# RECORD OF DECISION

**BALDWIN PARK OPERABLE UNIT  
SAN GABRIEL VALLEY SUPERFUND SITES  
LOS ANGELES COUNTY, CALIFORNIA**

**United States Environmental Protection Agency  
Region 9 - San Francisco, California**

Part III. Responsiveness Summary

Figure RS-2

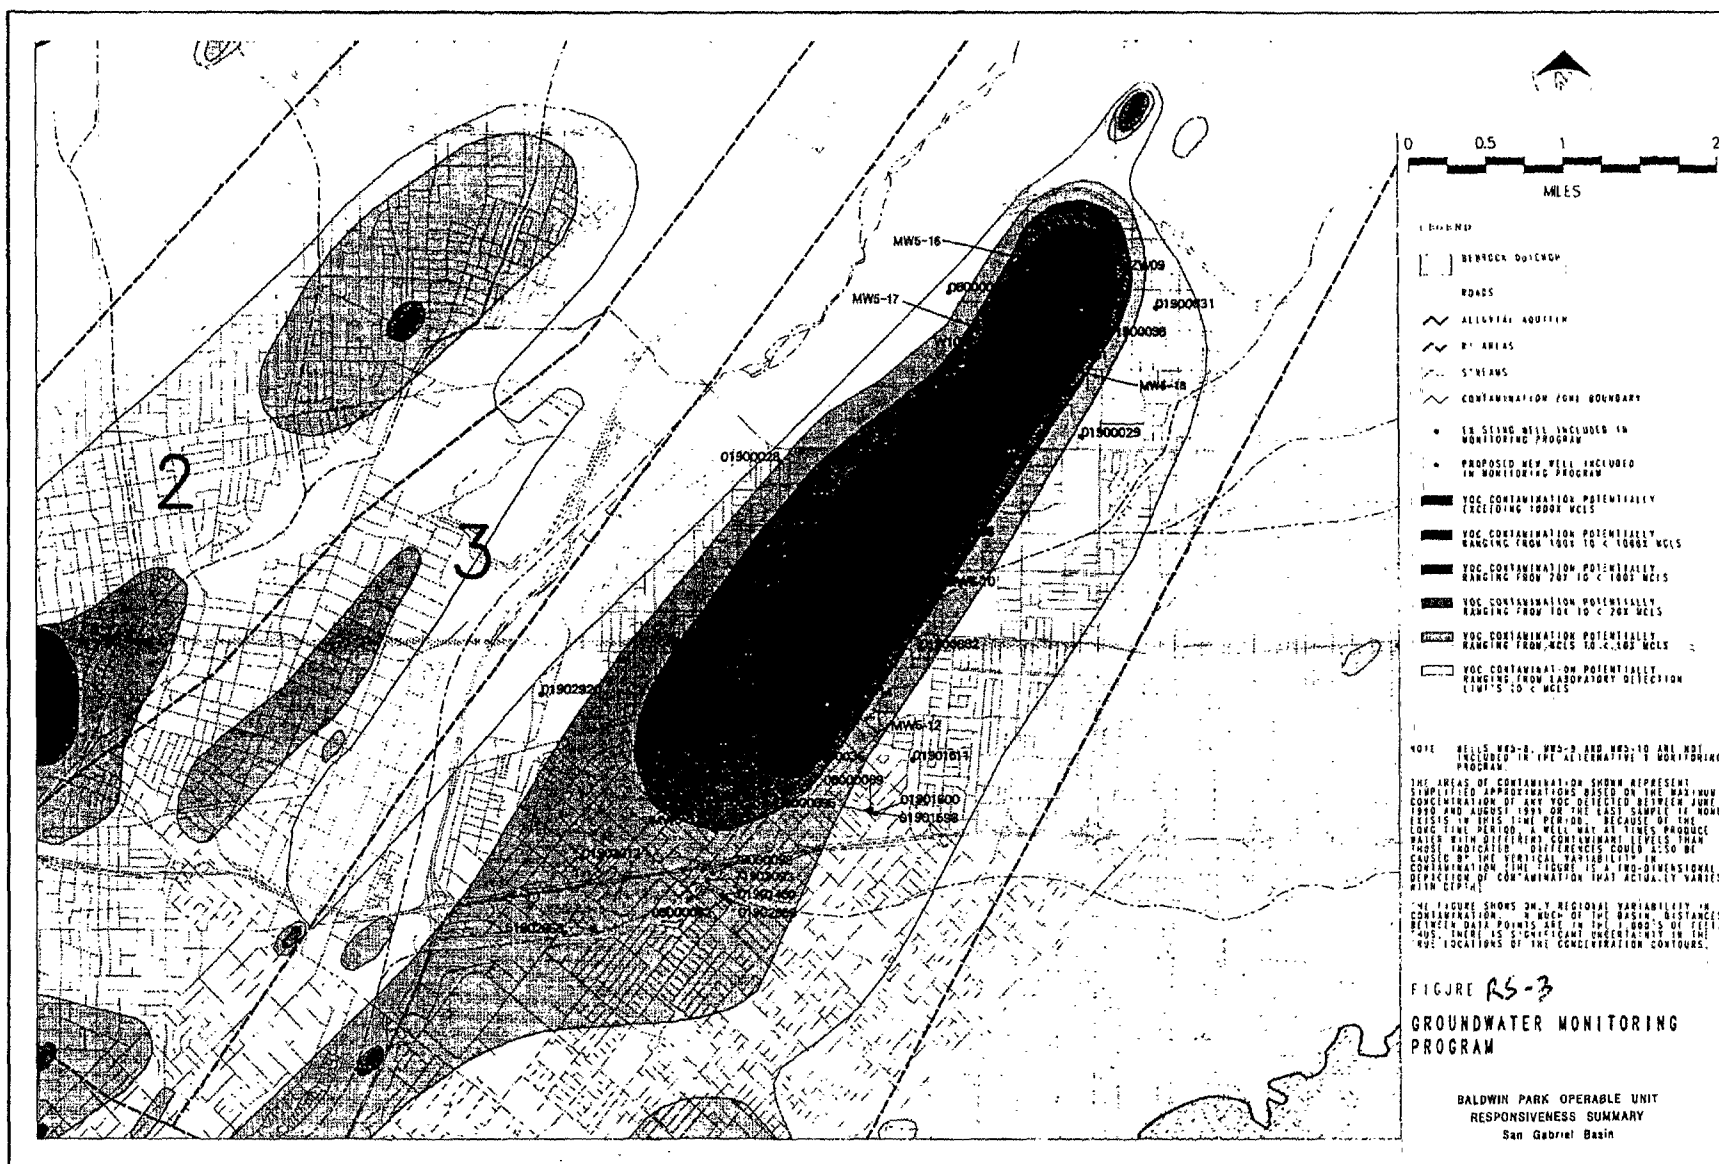
Aj#47. "Why were two different scales used for Figure 3-2 and Figure 3-1? For the purpose of comparing these two figures it would be beneficial to use the same scale for each figure, and to utilize a common scale for all similar figures."

We have prepared a revised figure (included as Figure RS-2) that includes well recordation numbers.

FIGURE RS-4  
SIMULATED CONTOURS  
OF GROUNDWATER ELEVATION  
38,500 GPM SCENARIO

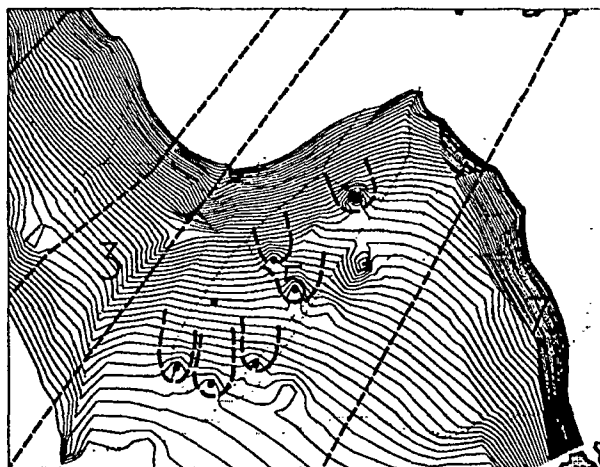
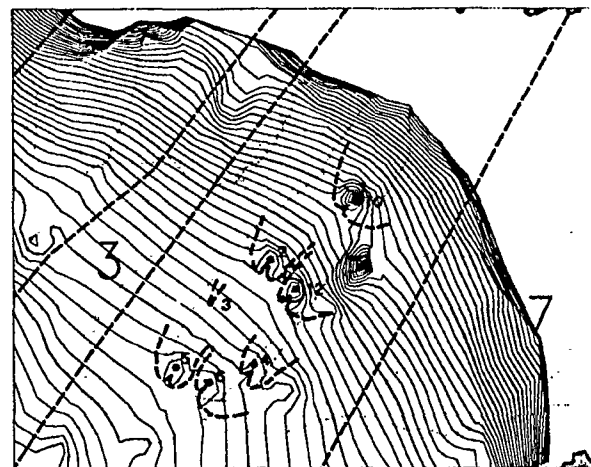
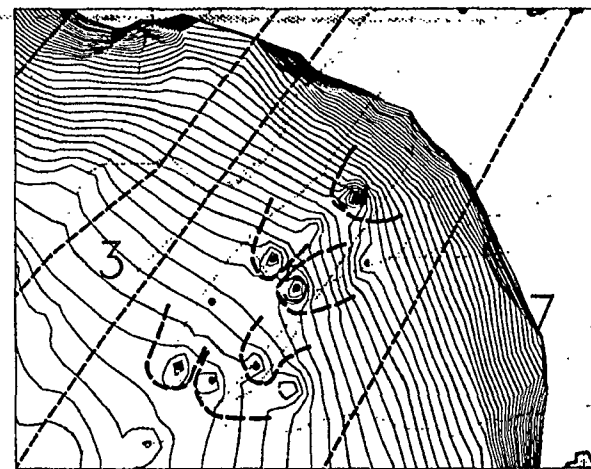
Aj#156. "It is unclear why Figure 7-8 presents the optimum well arrangement and rate for the OU. No selection criteria were established prior to discussion of simulation results, no capture zones are shown on the figure, the Subarea boundaries are not concentration related, and how each simulation arrangements achieves selection criteria is not discussed. To independently validate the selection of well locations and pumping rates, a significantly more detailed discussion on the modeling and selection procedure is needed."

EPA Response: We have added capture zones to Figures 7-5 through 7-8. They are included in this Responsiveness Summary as Figures RS-4 through RS-7. We have also added capture zones to Figure 12-2; the revised Figure is included as Figure RS-8.

Capture zones were not drawn on the referenced figure (or the rest of these groundwater contour figures) so that the reader can have an unobscured picture of the simulated groundwater contours resulting from the extraction scenario. As stated on page 7-12 of the FS, the zone of influence for each extraction well can be added to the figure for each quarter "by drawing lines perpendicular to the contours and noting whether they terminate at one of the potential extraction locations." However, revised figures are attached (Figure RS-4 to 8) that include approximate capture zones.
